1992 Corvette: Service Bulletin: Brake Pedal Not Fully Returning / Stop Lights Stay On and/or Roughness/Vibration From Rear of Vehicle

Model and Year: 1992 CHEVROLET CORVETTE

Bulletin Number: 92-71A-5 - (01/31/1992)

Figure 1

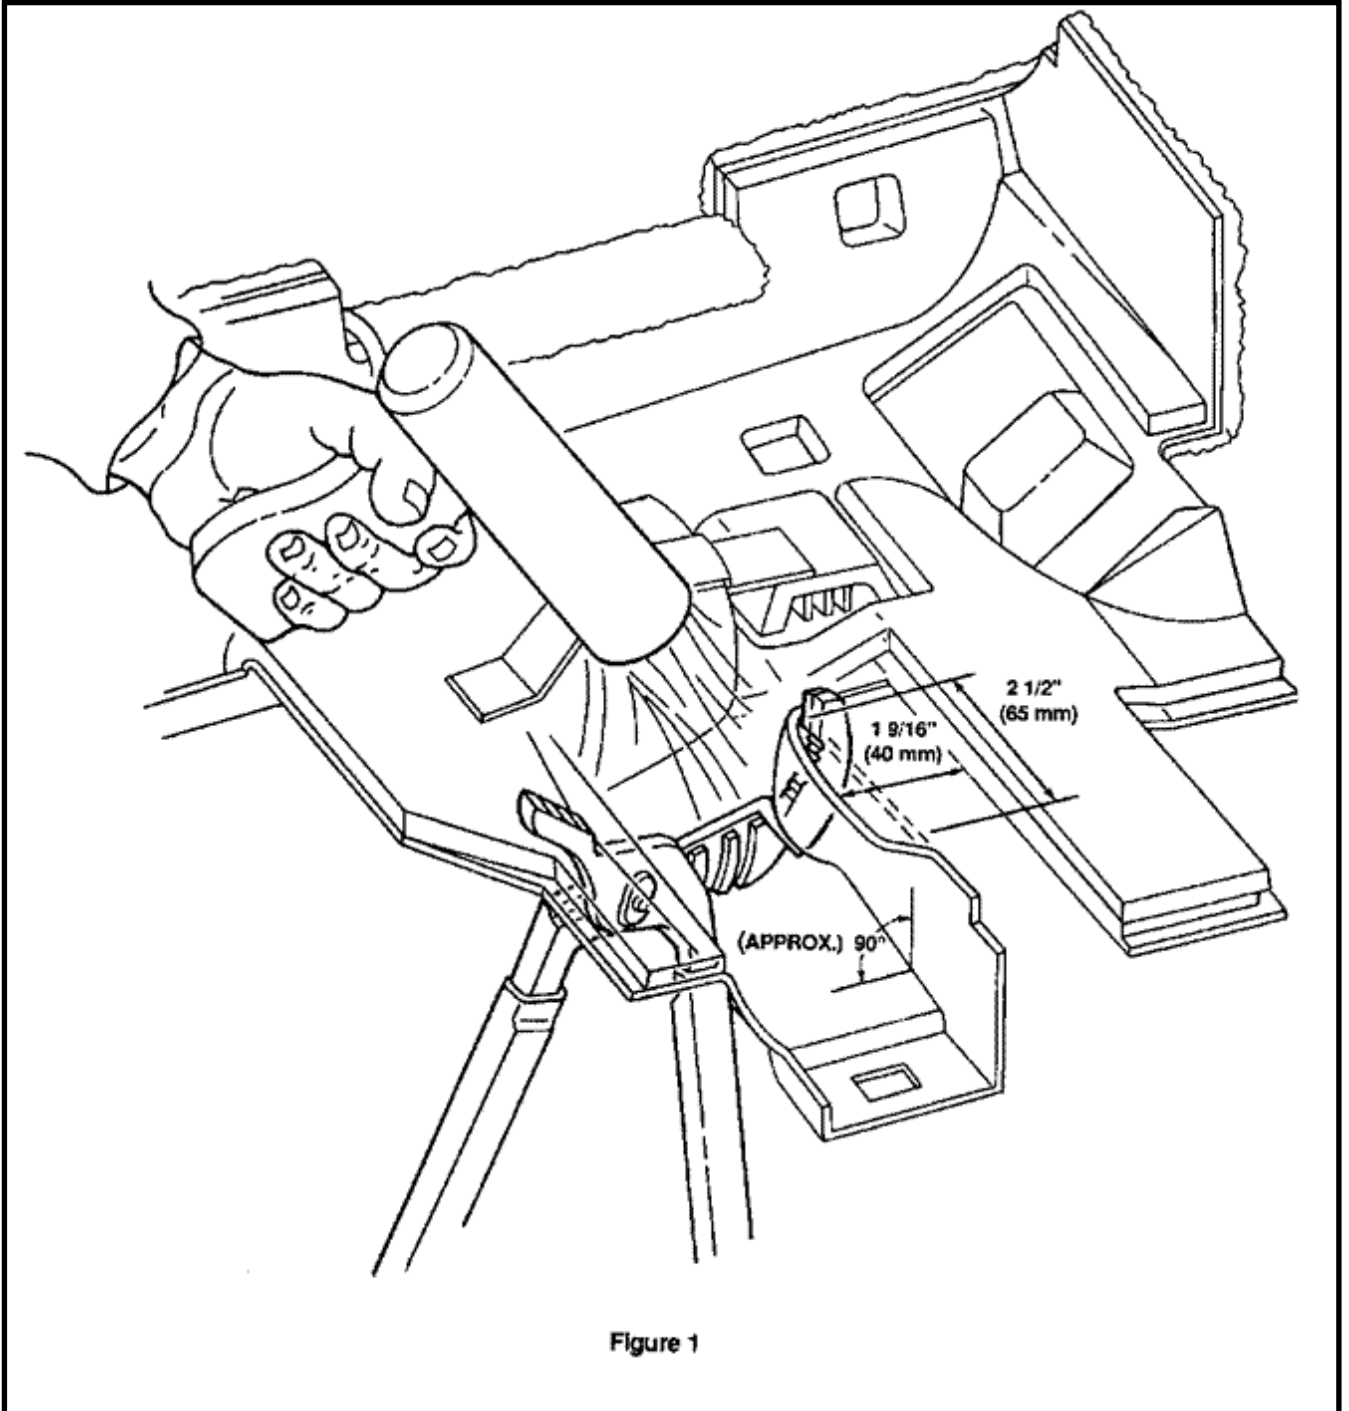
Some 1992 Y-car base Corvettes built from SOP to VIN breakpoint 104324 and ZR1's built from SOP to VIN breakpoint 800193 may exhibit inadequate clearance between the brake service pedal arm and the I/P lower trim panel.

Determine if interference exists between brake pedal arm and I/P lower trim panel (a minimum clearance of 2mm (.080 in.) is required). To verify clearance, an item approximately 2mm thick, such as a 2mm shim, should pass between the trim panel and pedal arm on both sides. If there is clearance, diagnose concern per Service Manual, Section 5-3. If the minimum clearance does not exist, perform the following steps:

1. Remove LH lower trim panel (per Service Manual, Section 8C-33).
2. Lift away the foam sound deadener from area shown in Figure #1, and tape out of the way.
3. Using a heat gun, warm the trim panel area shown in Figure #1 (USE CARE TO WARM COMPLETE AREA EVENLY).
4. Using Channel Locks (R) size 16 or larger, place near the upper LH corner of the I/P lower trim panel as shown in Figure 1. Quickly reform the brake pedal opening to configuration and dimensions indicated in illustration. If necessary Channel Locks may be moved downward during initial reforming and/or Steps 3 and 4 may be repeated to obtain minimum clearance of 2mm between the brake service pedal arm and the I/P trim panel.

Note: To lessen Channel Lock imprint, place smooth shim stock or aluminum face cover between the Channel Lock face and the warmed surface on the trim panel.

5. Reinstall lower trim panel. Remeasure the clearance between trim panel and the brake pedal arm, using method stated in correction above.
6. If contact still exists, phone Action Center #1 -800-457-8388.
